19 December 2023

Macquarie Point Multipurpose Stadium Draft Guidelines

Figure 5.5: Path widths for a 75/25 directional split

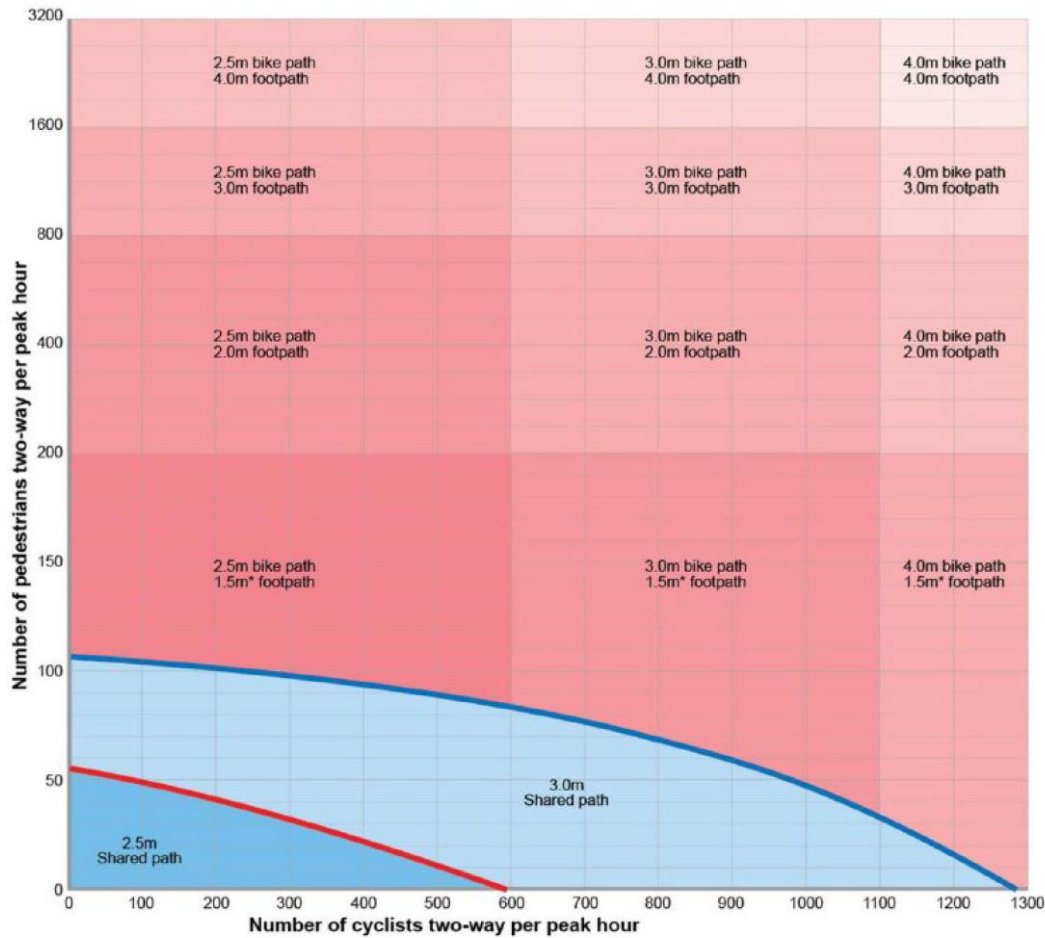
- The guidelines could refer to the 2017 Austroads *Guide to Road Design Part 6A: Paths for Walking and Cycling* as it is clear about when pedestrians and cyclists/scooters should have separated paths to avoid conflict and ensure safety.

It may be that the government chooses to achieve this separation by shutting down roads on event days for temporary separation rather than building permanent infrastructure, but the numbers in the Austroads matrix are useful for this planning.

The matrix also shows desirable widths for people walking and cycling. Cycling paths in particular need more space to allow other riders to pass safely and to accommodate cargo bikes and three-wheelers that take up more space than a standard bicycle. Adequate widths will also allow wheelchairs and other mobility devices to safely use the paths.

The following graph shows that for most of the area directly connecting to the precinct, there would need to be separation of people walking and riding to avoid conflict during major events:
